**SOLICITATION AMENDMENT
MODIFICATION DE L'INVITATION**

Title - Sujet Centre des visiteurs Green Gables	
Solicitation No. - N° de l'invitation ED001-181274/A	Amendment No. - N° modif. 006
Client Reference No. - N° de référence du client R.081199.001	Date 2017-10-13
GETS Reference No. - N° de référence de SEAG PW-SPWC-024-4190	
File No. - N° de dossier PWC-7-40074 (024)	CCC No./N° CCC - FMS No./N° VME
Solicitation Closes - L'invitation prend fin at - à 02:00 PM on - le 2017-10-18	Time Zone Fuseau horaire Atlantic Daylight Saving Time ADT
F.O.B. - F.A.B. Plant-Usine: <input type="checkbox"/> Destination: <input checked="" type="checkbox"/> Other-Autre: <input type="checkbox"/>	
Address Enquiries to: - Adresser toutes questions à: Bysterveldt (PWC), Crystal	Buyer Id - Id de l'acheteur pwc024
Telephone No. - N° de téléphone (902) 940-7122 ()	FAX No. - N° de FAX (902) 566-7514
Destination - of Goods, Services, and Construction: Destination - des biens, services et construction:

LE PRÉSENT ADDENDA VISE À PRÉSENTER LES RÉPONSES SUIVANTES AUX QUESTIONS POSÉES PAR LES SOUMISSIONNAIRES.

**GREEN GABLES—PHASE 2
BARN EXPANSION
AND RENOVATION**

DETAIL - CONNECTION TC34

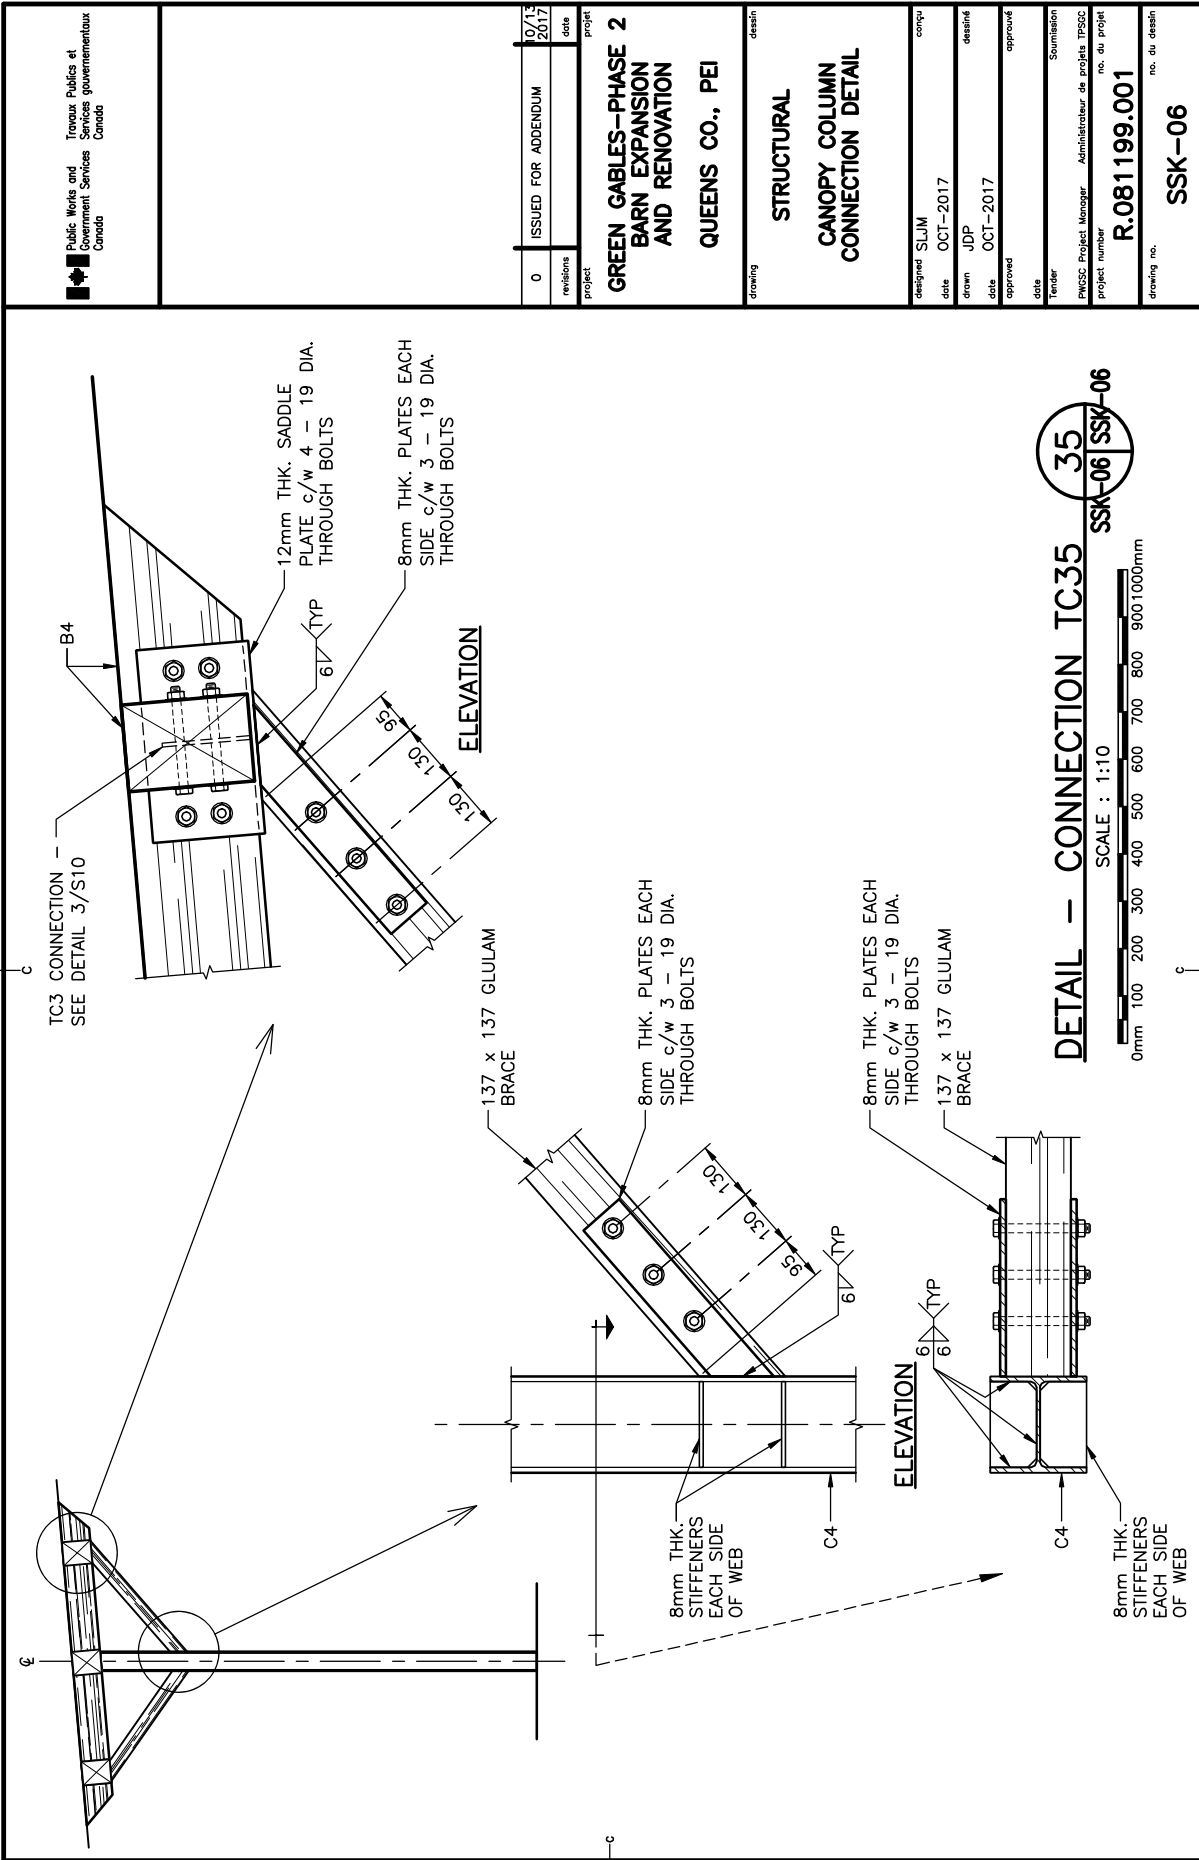
4. **Question:** What are the connection details for the members of the two entry canopy structures between gridlines 9 and 10, as seen on EL9/S06 and on S03?

Answer: Reference Drawing S03 –Roof Plan. At the entry canopies add note TC34 for connection of the B4 beam to the column, see attached SSK-05 for connection detail.
